Presentation of the Final Report

STRESS CORROSION CRACKING

Peer Panel on Waste Package Materials Performance

U. S. Department of Energy (DOE)
Bechtel SAIC Company, LLC (BSC)

Threshold Stress Intensity Factor Model

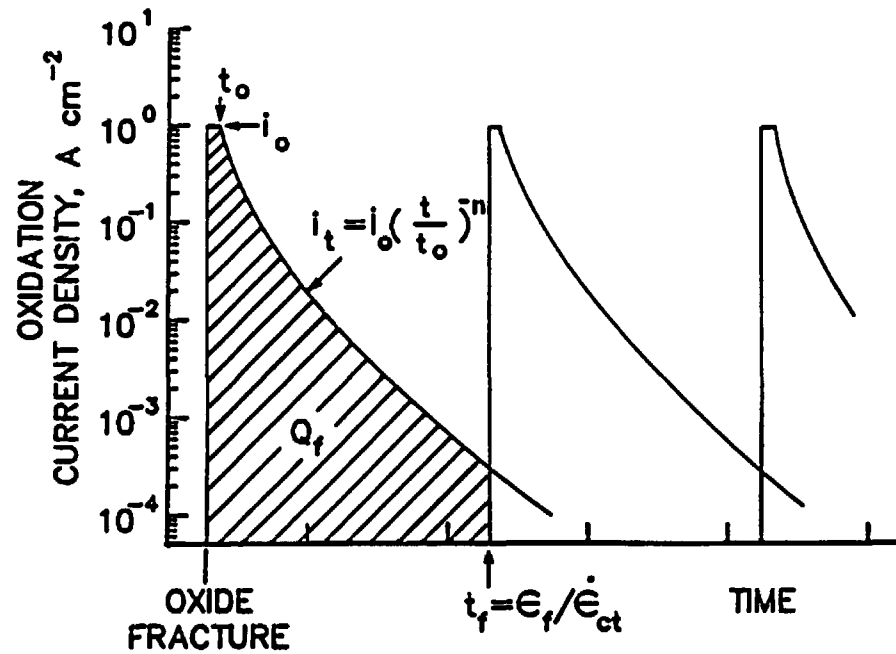
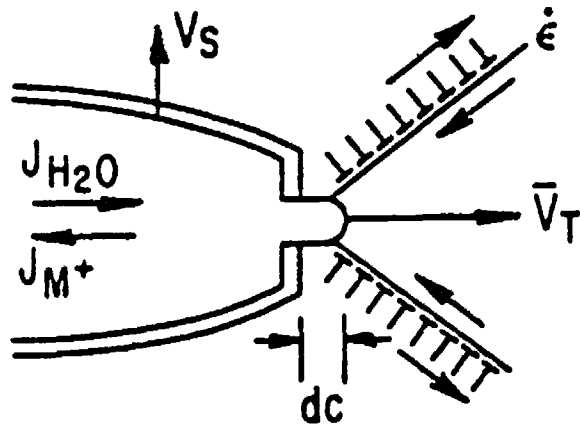
- ❑ **Sensitivity to crack growth not addressed in DOE work**
- ❑ **Some scientists have speculated that K_{ISCC} does not exist**
 - ◆ **Lower limit of sensitivity to crack growth**
- ❑ **CNWRA estimates maximum sensitivity of 10 μm based on fractography**
 - ◆ **For a one year test, this sensitivity would correspond to through wall penetration for 25 mm waste package with a 5 mm deep preexisting flaw in 2000 years**

- **The maximum sensitivity to crack growth be established and improved**
 - ◆ **Threshold stress intensity factor tests**
 - ◆ **Crack propagation tests**
- **Slip dissolution/film rupture model**
 - ◆ **Threshold stress component be replaced with the threshold stress intensity factor model**
 - ◆ **Develop model constants specific to Alloy 22**

Alloy 22, Slip Dissolution Model

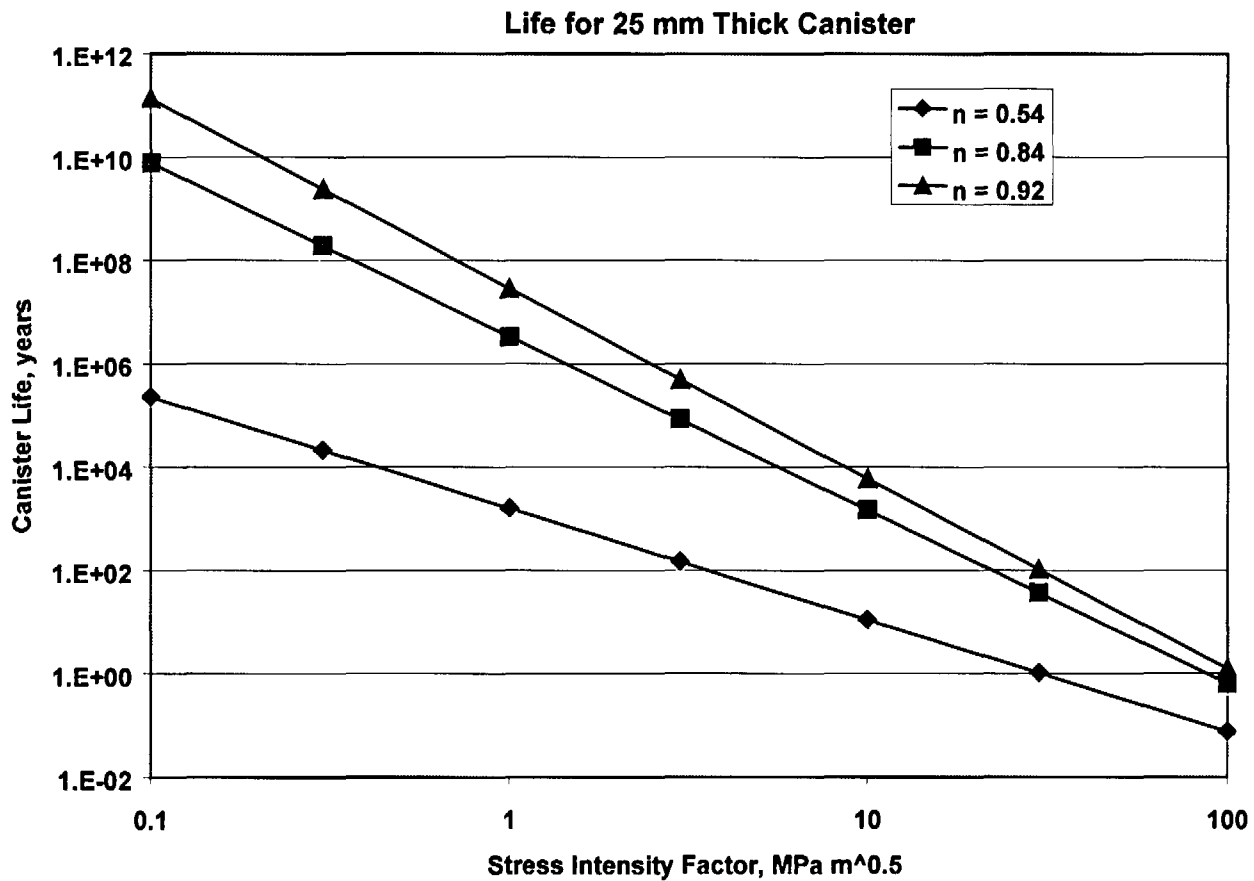
**Stress intensity factor must be less than about
 $10 \text{ MPa(m)}^{0.5}$ to obtain a 10,000 year life**

- Assumes a constant crack growth rate with time and decreasing temperature**

Through-Wall Stress in Laser Peened Areas

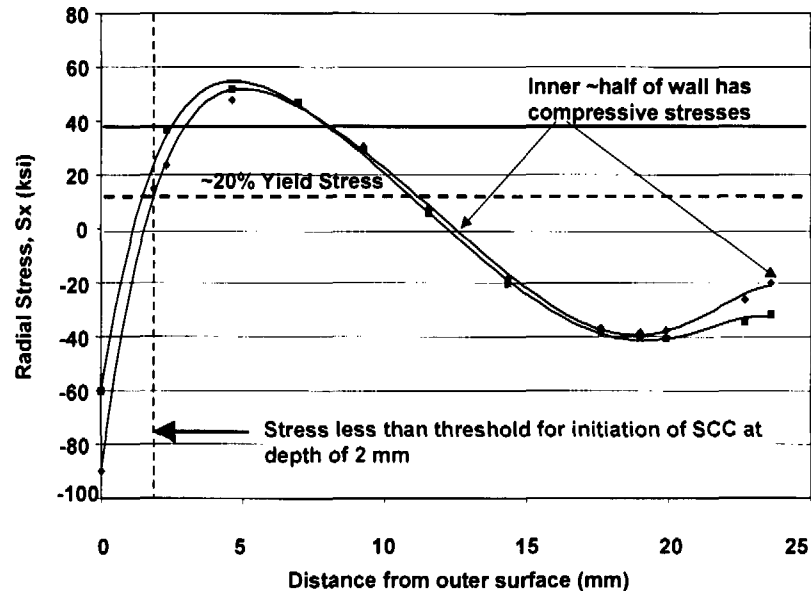
- **Residual tensile stresses also might exist in transition zones for laser peening and local induction annealing treatments**

- **Project thoroughly evaluate heat treatment procedures for stress mitigation**
 - ◆ **Modeling**
 - ◆ **Measurements on prototype containers**
